Architectural Review Board Meeting Agenda

1. Project: Sobesky-Mathers Residence Exterior Alterations, 21-2127-CDP/ARB
Address: 5353 Eighth Street
Applicant: Eva Sobesky, EIS Studio, agent for Eva Sobesky and Todd Mathers
Planner: Syndi Souter

Agenda Item #1

**COMMUNITY DEVELOPMENT DEPARTMENT
PROJECT REVIEW**

A3-1.1

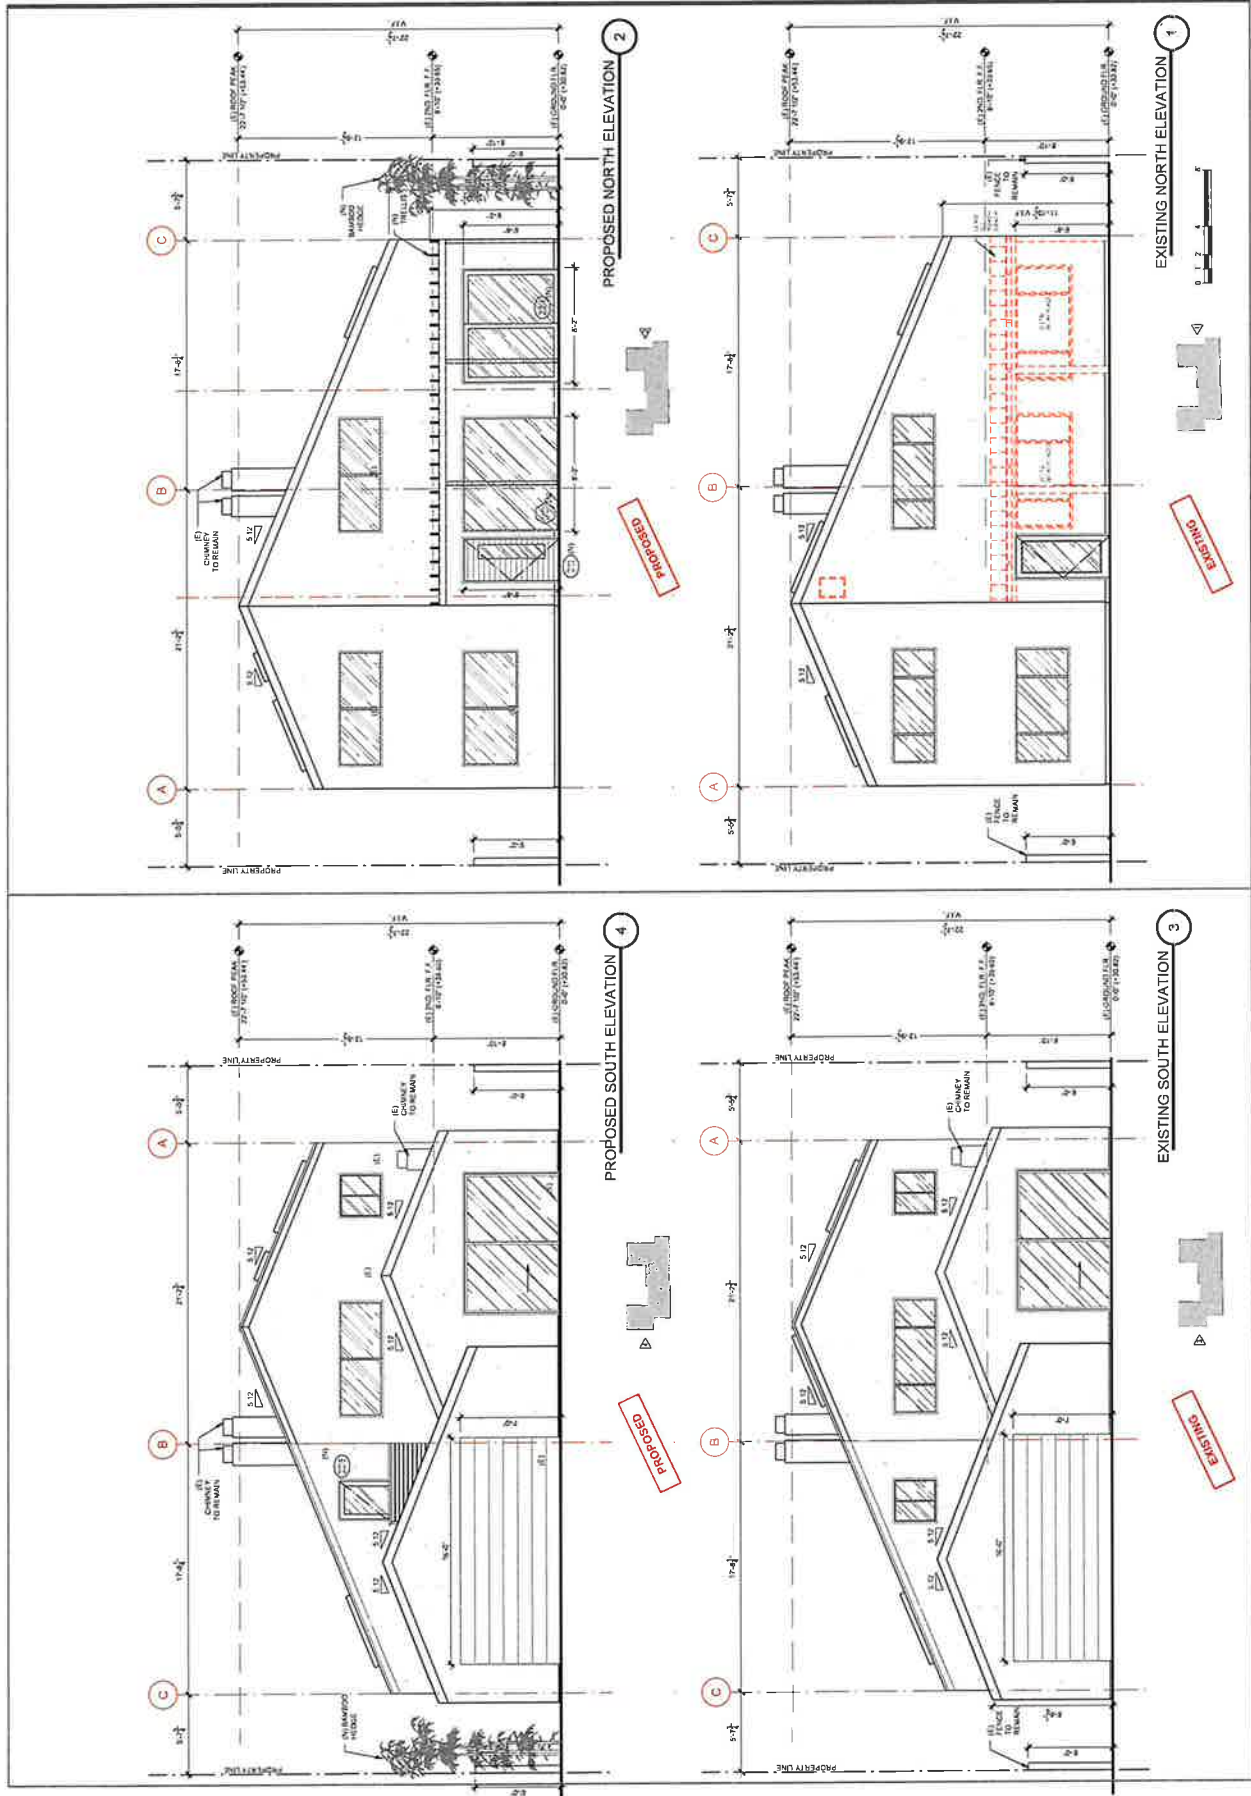
Bandmember Johnson recommended additional landscaping along the western property line, other than Podocarpus, to provide screening and privacy. He suggested a solid wall around the base of the balcony to increase privacy for both properties would be beneficial. He was glad to see that the bumps in the stucco will be going away and the new upgrades to the building. He requested construction details on the deck and trellis including materials and finishes.

4. The balcony has been revised to have opaque frosted glass panels on the western side with wire railing on the south side (see Sheets A3-1.1, A3-1.3, and A4-1.1).

A3-1.2

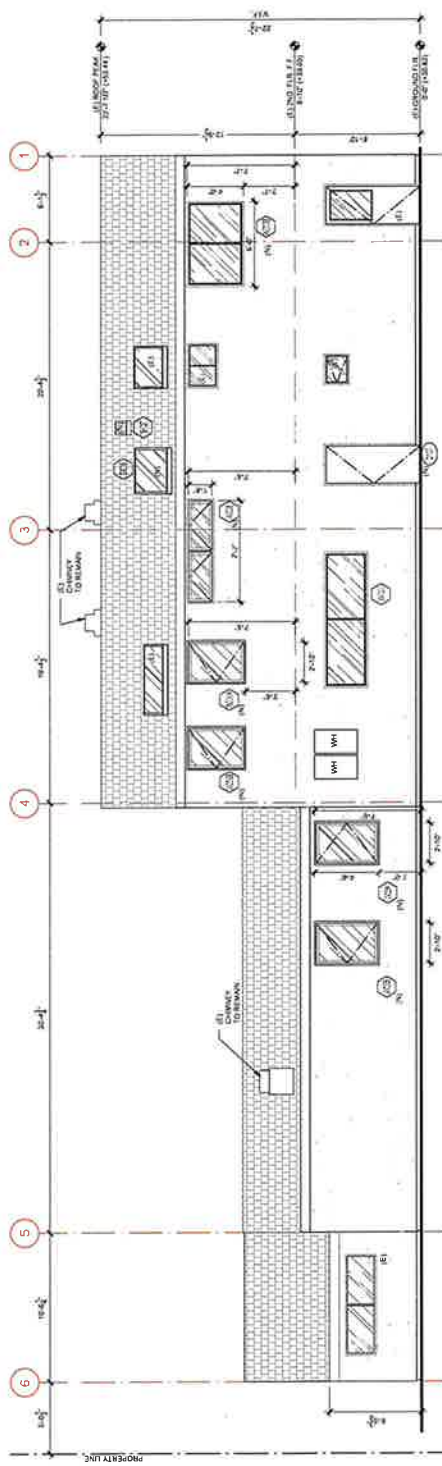
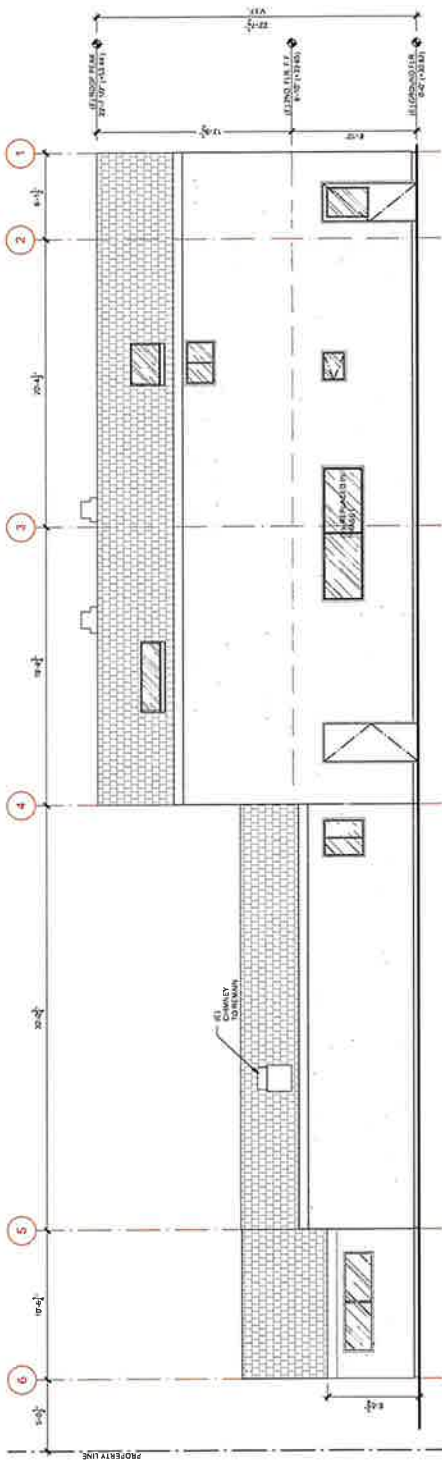
- The headers for the second-story windows on the east elevation should all be at the same height,
- The proposed exterior lights should be low wattage with recessed lenses to avoid spilling onto the neighbor’s property,
- Add additional landscaping along the western property line for privacy/screening with a condition of approval that the landscaping be maintained for the life of the project,
- The balcony should have a solid wall for privacy,
- Provide construction details for the patio and balcony, and
- Consider having fewer doors open onto the balcony.

Boardmembers Johnson and Blakemore questioned why the header for the northern window on the east elevation was a foot lower than the other two proposed windows, and made the suggestion that the header should be raised to match the other windows.

1. The headers on the second-story windows on the east elevation are now all at the same height (see Sheet A3-1.2).
2. A new exterior light fixture has been selected that has a hooded and shielded element to prevent light from spilling into the neighbor's yard (see the cut sheet included in the Colors & Materials, attached as Exhibit C).

A3-1.3

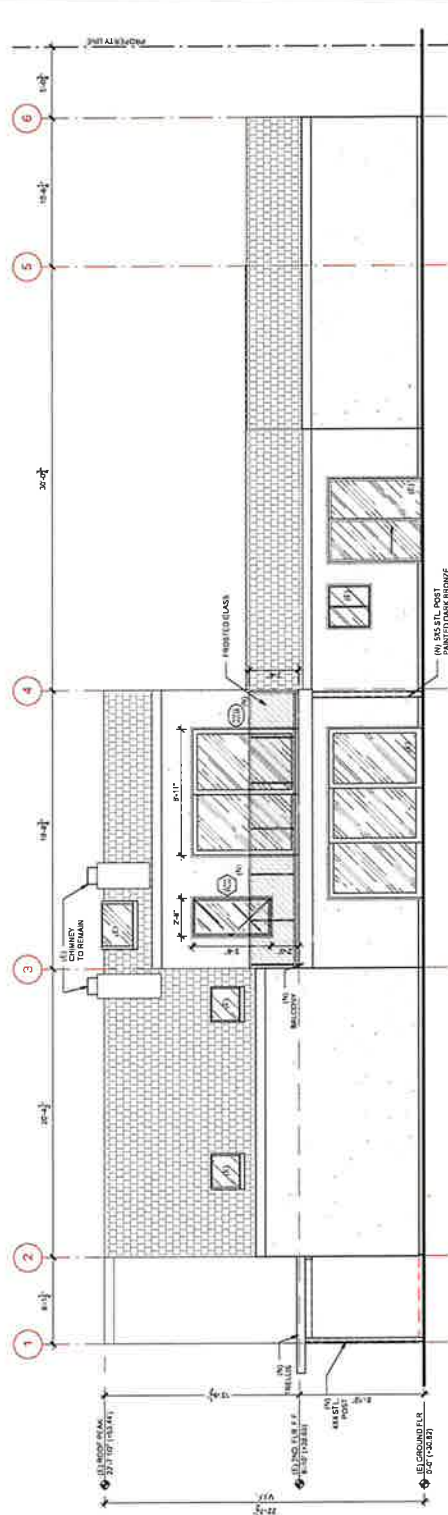
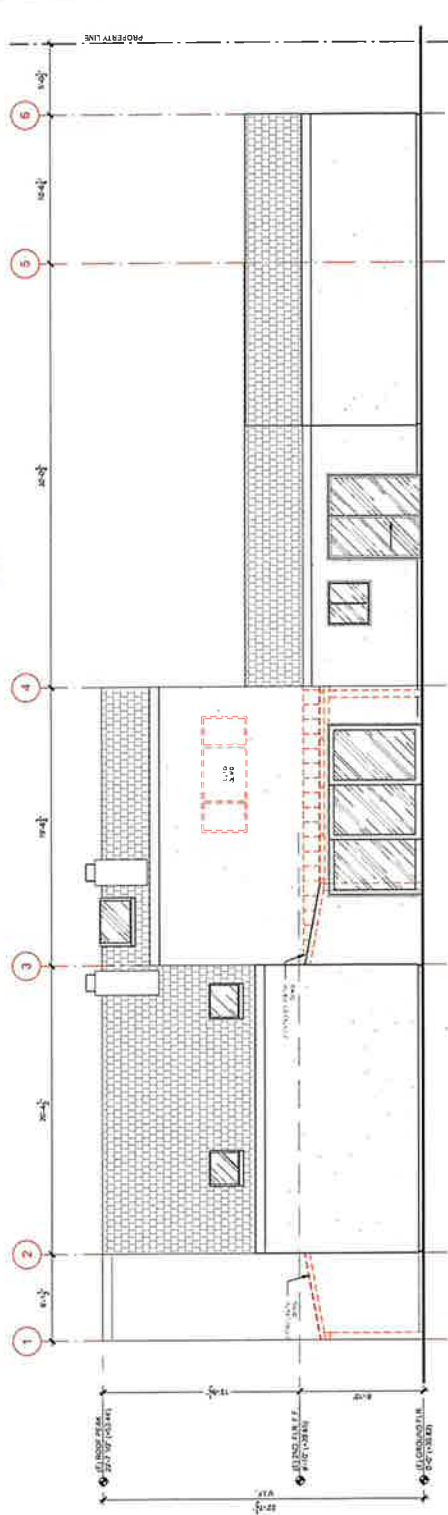
Boardmember Rodriguez agreed that screening is important for privacy with plants or a taller wall. He felt that the location of the balcony was acceptable, but that it was accessed by too many doors. He suggested that the balcony should be accessed only from the master bedroom and that the other doors could be replaced with smaller windows. He supported the removal of the “hump and bump” stucco. He liked the new front trellis. He referenced Design Guideline #26 for the Beach Neighborhood,

5. Details for the construction of the balcony and support posts have been provided (see Sheets A8-1.1 and S2.00).
6. The door out to the balcony at the top of the stairwell has been replaced with a window (see Sheets A2-1.2 and A3-1.3).

\$2.00

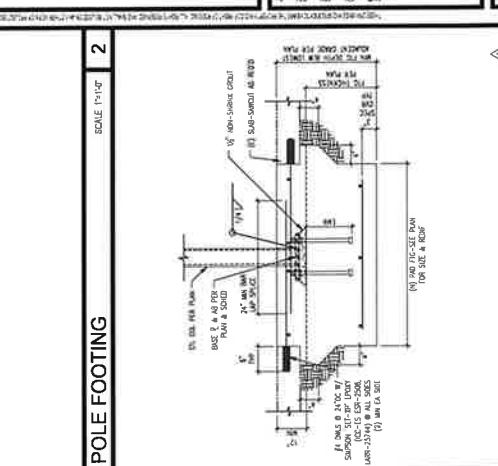
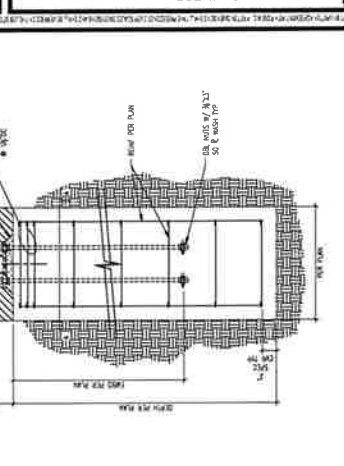
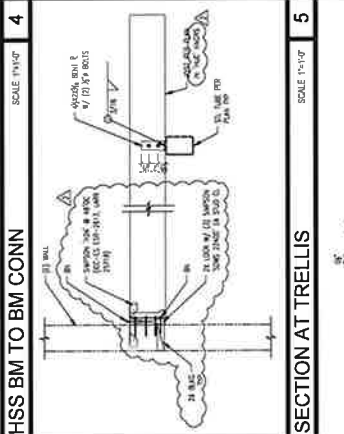
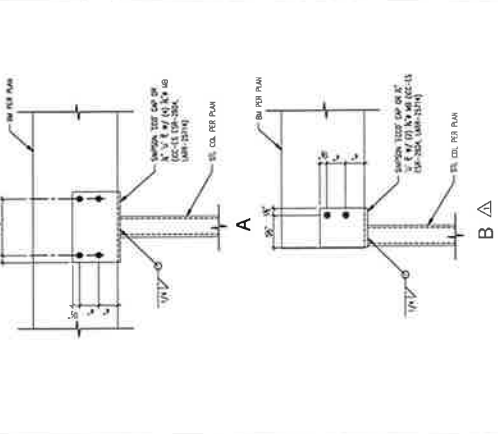
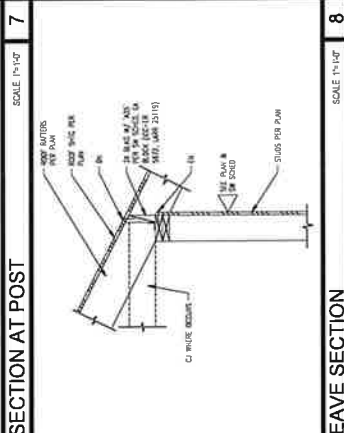
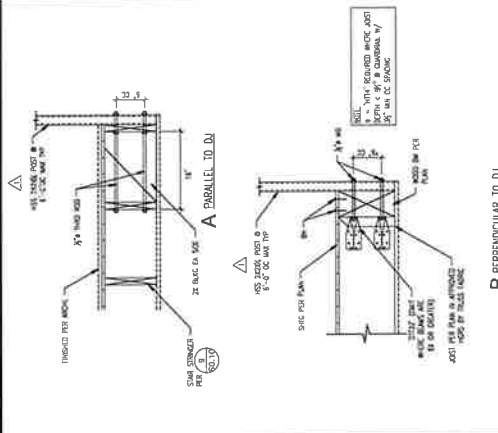
asked about the columns for the balcony supports, and she responded that they were rotten and would need to be replaced. He requested a detail for the replacement posts, and asked about the proposed window materials. Ms. Sobesky responded that the windows would be aluminum in a light bronze color. Ms. Sobesky asked about the maximum fence/wall heights and suggested they could add some large plants for a fast-growing screen.
